Date: November 3, 2022
To: Dealer Principal, General Manager, Service Manager
From: Richard Kenton, Technical Director
Dan Schwartz, Service Area Manager

We would like to inform you that, to reduce the above-mentioned condition, a neoprene pad and a new upper chain sliding shoe have been introduced (from VIN ZDM1A00AANB013952) for the Multistrada V4 MY2022. This solution can also be applied to the Multistrada V4 Model Year 2021.

- 1. VIN number: **ZDMXXXXXXXXXXXXXXXXX**
- 2. Claim Type: WCRC WARRANTY CLAIM RECALL CAMPAIGN
- 3. Recall Campaign: CR241 SRV-TSB-22-015 REPLACEMENT OF MTS V4 UPPER CHAIN SLIDING SHOE

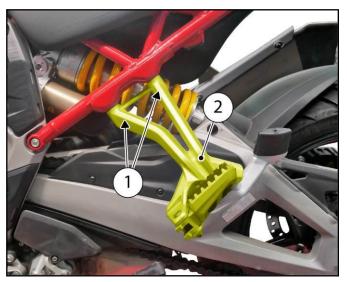
The purpose of this bulletin is to help you deal with this type of customer complaint, and then guide you through the installation of the **upper chain sliding shoe** (Part No. 44712611A) with the application of the new **neoprene pad** (Part No. 86613441A) on motorcycles that have not been upgraded yet.

- Part no. 44712611A: Upper Chain Sliding Shoe
- Part no. 86613441A: Neoprene Pad

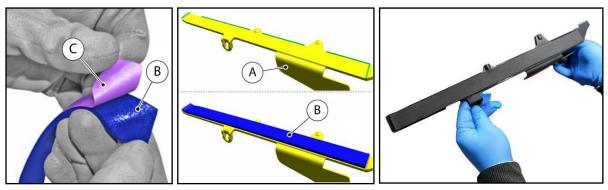
7. Position the new sliding shoe (A) Part no. 44712611A in a bench vice. With a felt-tip pen, mark where to make the cut on the **upper chain sliding shoe (A)**, as shown in the figure.

8. Cut the upper chain sliding shoe, taking care not to damage it.

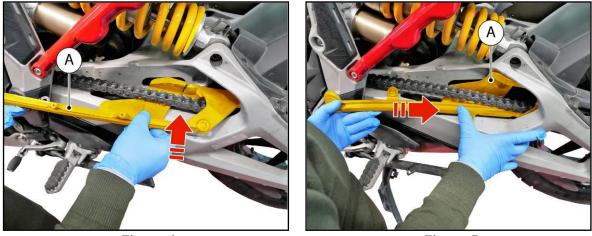
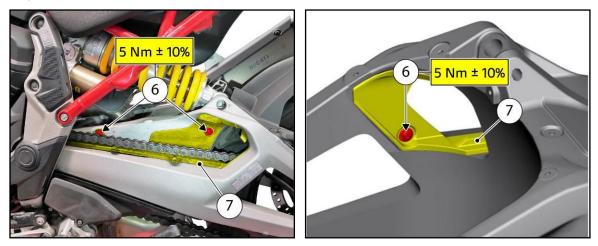
9. Take the **neoprene pad (B) Part no. 86613441A** to be applied to the **upper chain sliding shoe (A)**.

Remove the **double-sided adhesive film (C)** and apply the **pad (B)** on the lower side of the **upper chain sliding shoe (A)**.

10. Position the **upper chain sliding shoe (A)** inside the swinging arm, <u>routing the final drive</u> <u>chain through the cut made previously</u> (*Figure A*).

Insert the rear part of the **upper chain sliding shoe (A)**, as indicated by the arrows, inside the swinging arm *(Figure B)*.

Position the front part of the **upper chain sliding shoe (A)** (*Figure C*).

Finally insert the front part of the upper chain sliding shoe (A) (Figure D).

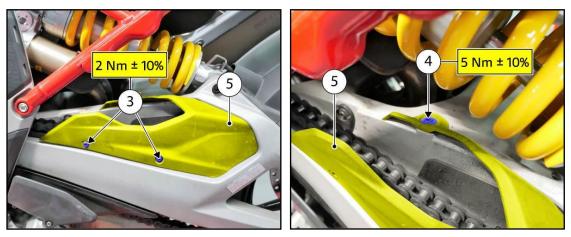
11. Apply LOCTITE 243 to the threads of the **3 M5 screws (6)**. Tighten the **3 M5 screws (6)** to a torque of <u>5 Nm ± 10%</u>.
